Case #H-93-26. 435 Arroyo Tenorio. Core Historic District. Chapman Homes proposes one story, single-family residence.

Case #H 93-26 Meeting Date February 22, 1993
 Project Address 435 Arroyo Tenorio District Core
 Agent _____ Address _____ Phone _____
 Owner Chapman Homes Address 1500 St. Francis Dr. Phone 983-8100

CASE #H- 93-26 ADDRESS 435 ARROYO TENORIO

PLAN

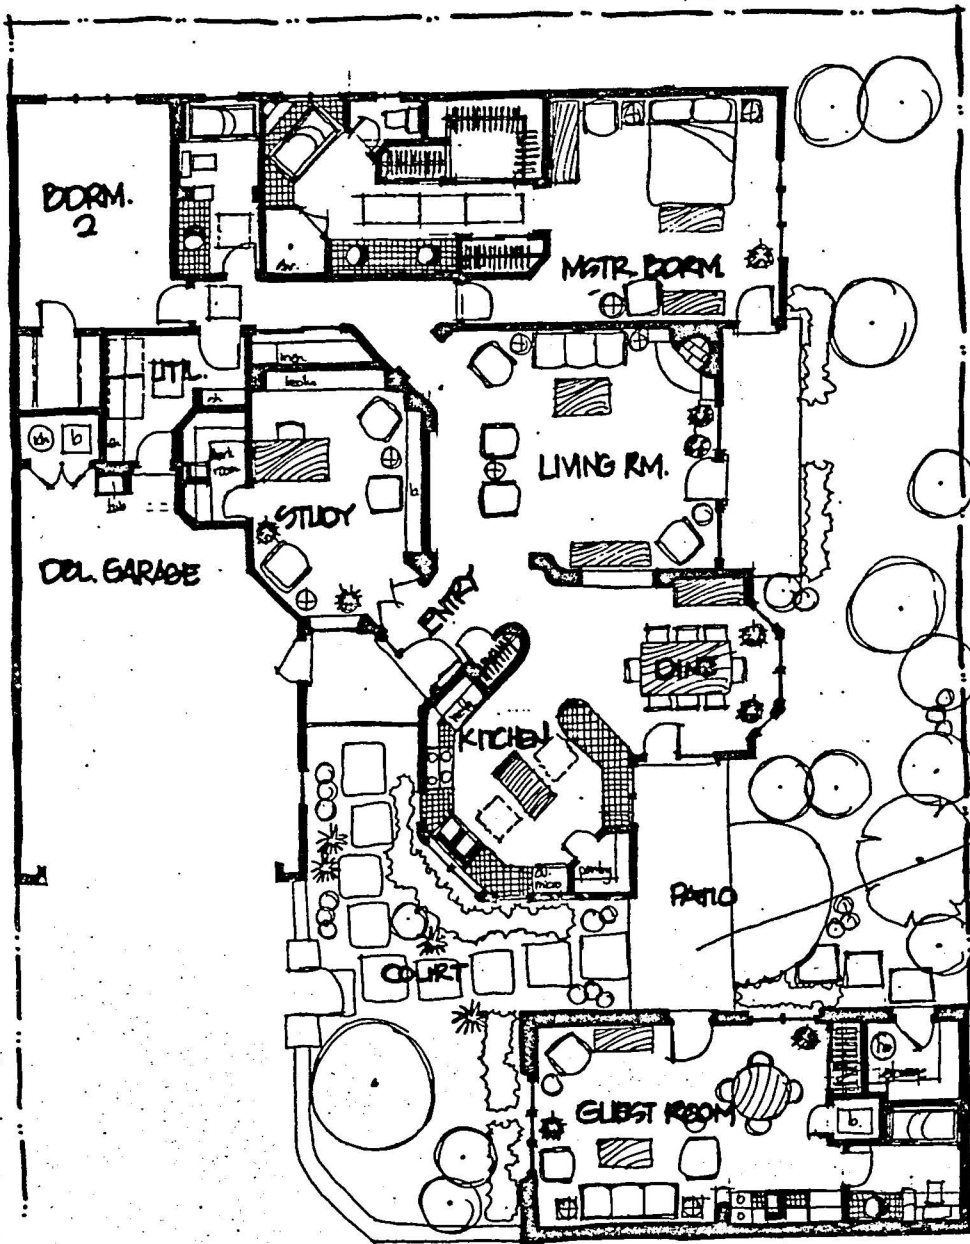
Mr. Cohen asked what material would be used for the garage door. Mr. Parmer said that it would be painted wood, to match the rest of the trim.

Mr. Bennett observed that the angles proposed for some of the rooms were incongruous with the buildings in the area.

Mr. Drew asked about the windows coming into the kitchen. Mr. Parmer stated that there was only 1½', so he thought these would have to be eliminated to meet the 3' rule.

Mr. Parmer replied that these angles are not publicly visible. He said that he would agree to change the visible portion, but at the rear it was not visible, because there was a 6' wall.

Mr. Martinez asked the applicant if he would modify the bay window. Mr. Parmer stated that, while he would agree with the comments about the angles on the front of the building, the bay window was not publicly visible. Mr. Martinez asked staff if it was not correct that the Board has a letter from the city attorney indicating that, if any portion of a structure is publicly visible, the entire building is within the Board's jurisdiction. Ms. Grzeskowiak stated that it was correct that the Board did have such a memo. Mr. Parmer stated that, in this case, he would re-work the window and take it to a square window. He said that he would also square off the kitchen and he indicated this on the plans.

Mr. Martinez moved approval of **Case #H-93-26**, as amended in the drawings. The motion was seconded by Mr. Bennett and passed by voice vote, with Mr. Drew voting "Nay".
